University of California Riverside
Glen Mor 2 Student Apartments Project
Final Environmental Impact Report
Volume 1 of 4 Responses to Comments,
Draft EIR Text Changes, and Mitigation Monitoring Program

**UNIVERSITY OF CALIFORNIA, RIVERSIDE
GLEN MOR 2 STUDENT APARTMENTS PROJECT
FINAL ENVIRONMENTAL IMPACT REPORT**

April 2011

Appendix B1
Shadow Diagrams

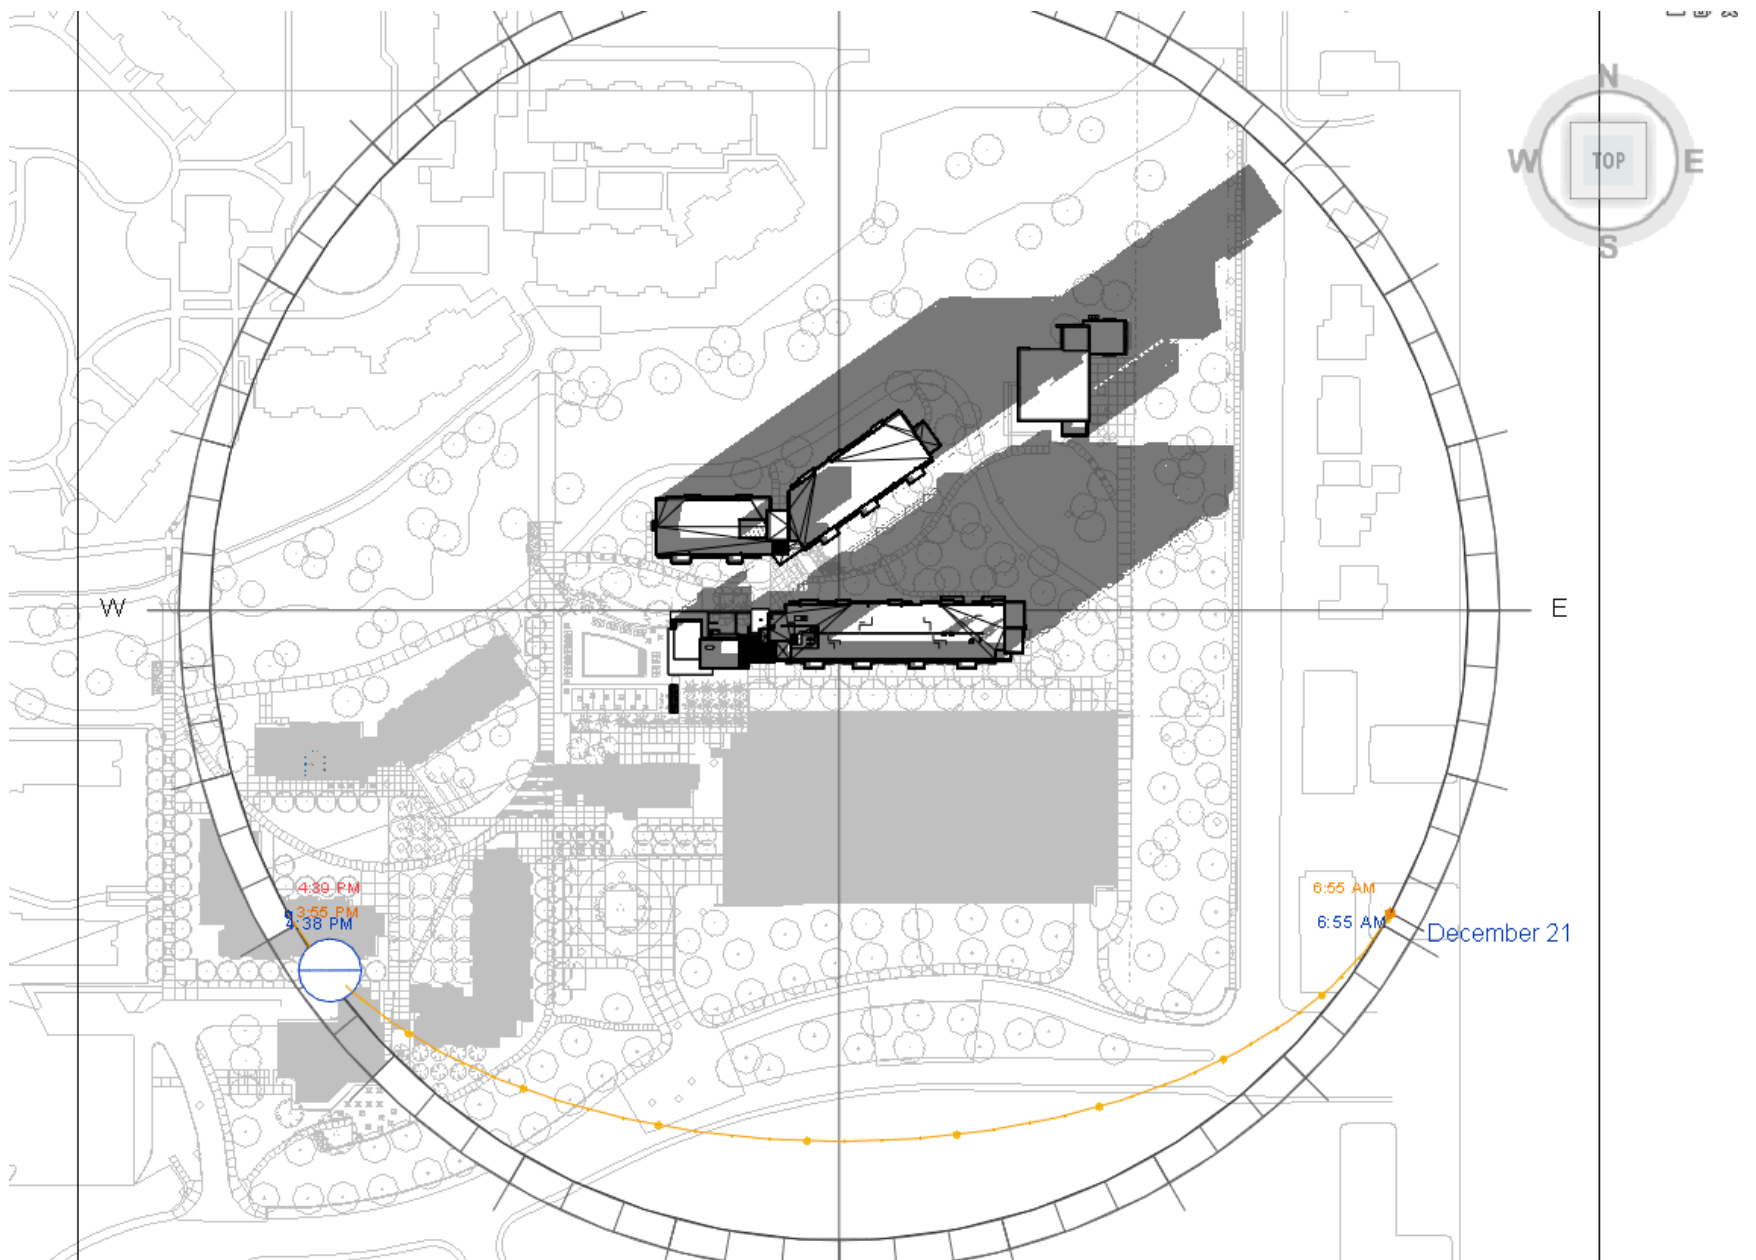
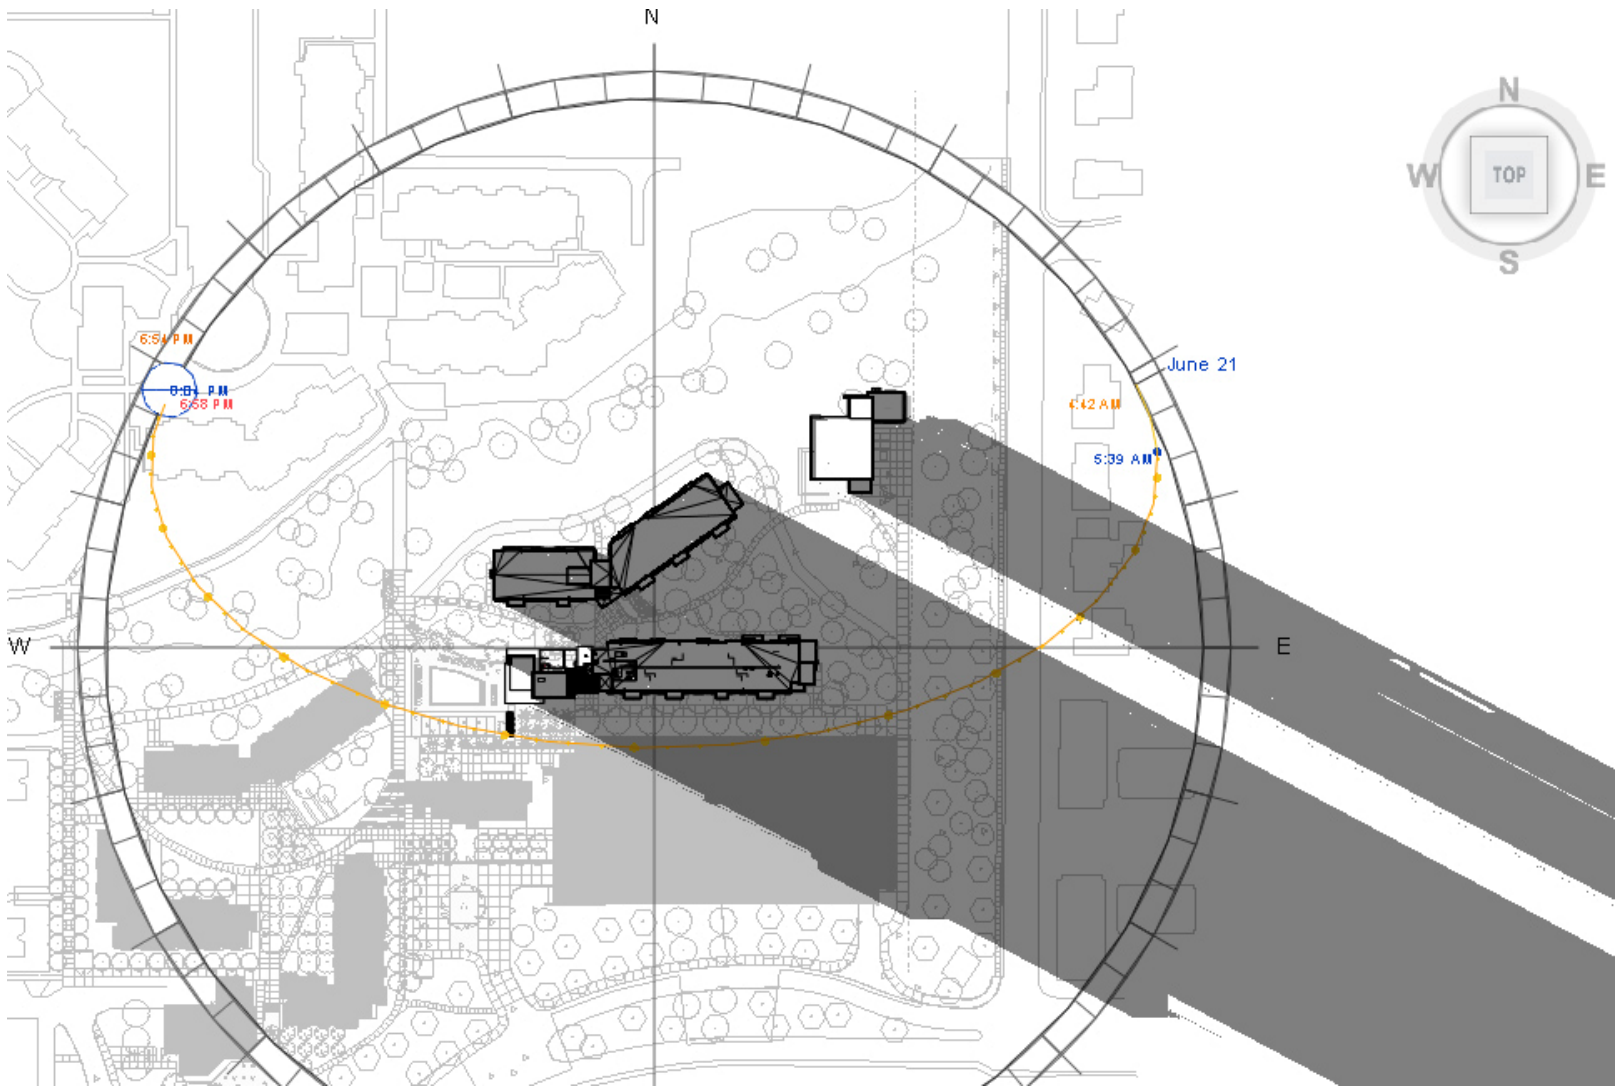
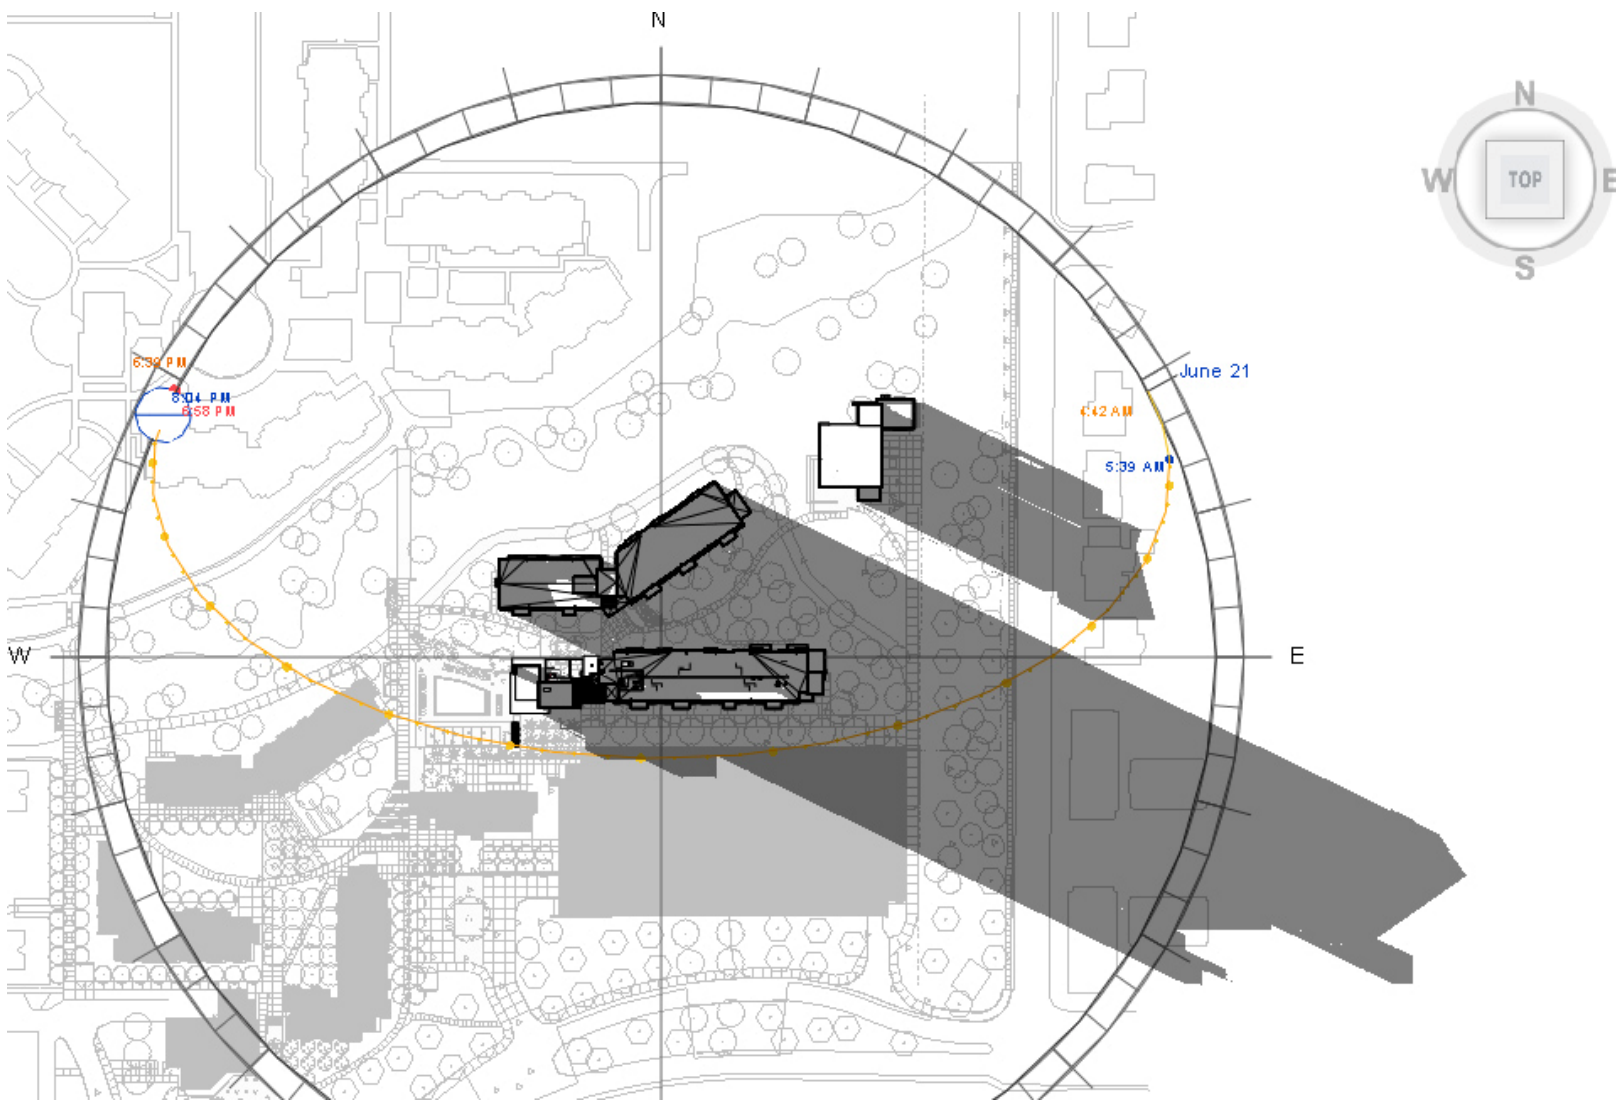
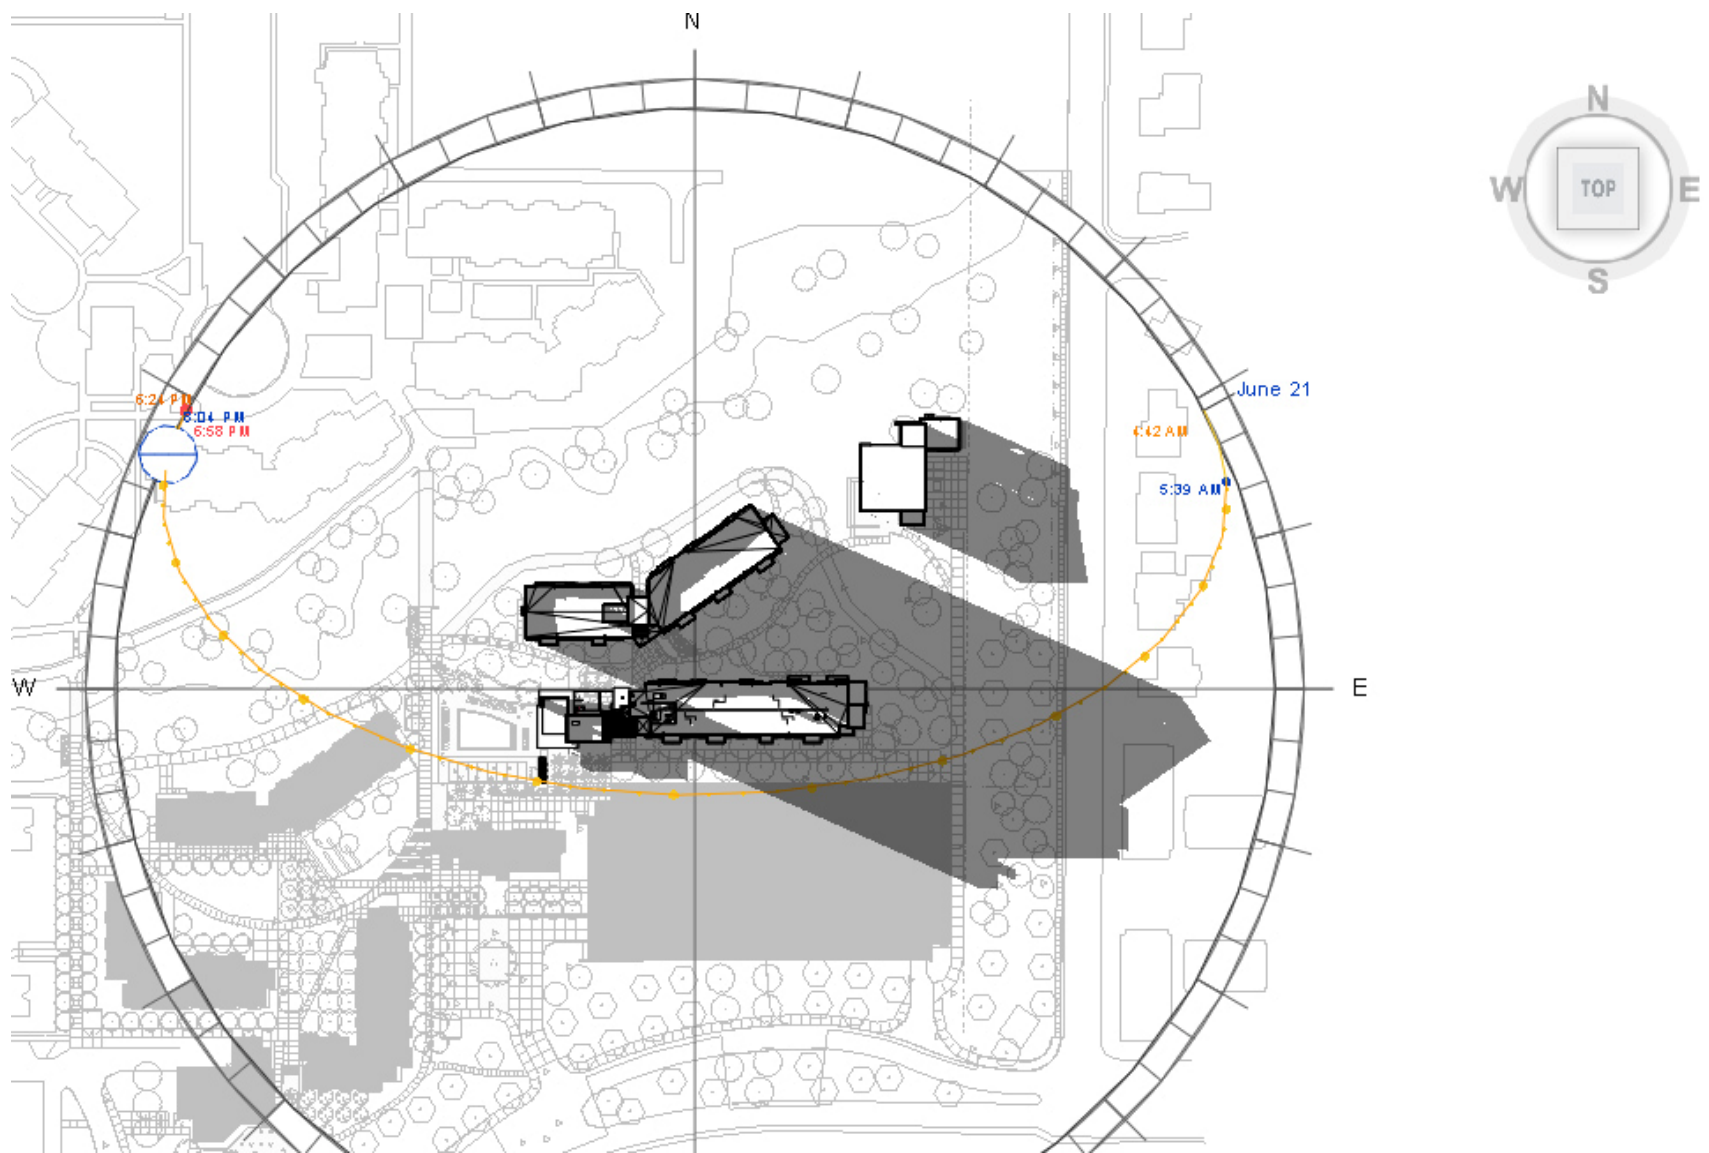
The planned dormitories may be significantly higher than the existing dormitories further inside the campus. It is unclear if and to what extent the foundations are planned to be sunken within the natural hill on the site or placed behind it.

The project architect has prepared a series of diagrams that depict shadow conditions created by the proposed buildings for the extreme circumstances associated with winter solstice and summer solstice. These diagrams have been added to the EIR as part of the Final EIR errata (Appendix B.1). The diagrams illustrate comparatively limited effects to shadowing of off-campus areas. Due to the relative position of the buildings and the movement of the sun, the area of concern is east of the campus, generally south of Goins Court. For the Winter solstice, shadows extend in a northeast direction and may be cast upon three single-family residential parcels east of Valencia Hill Drive for a period of less than 30 minutes immediately before sunset. For Summer solstice, shadows are cast in a southeast direction, and may be cast upon three single-family residential parcels and the University Village Apartments along Big Springs Road, east of Valencia Hill Drive. For summer, shadow effects on off-campus properties would be perceived for approximately 90 minutes prior to sunset. Furthermore, please note that most of the existing structures that would be affected by
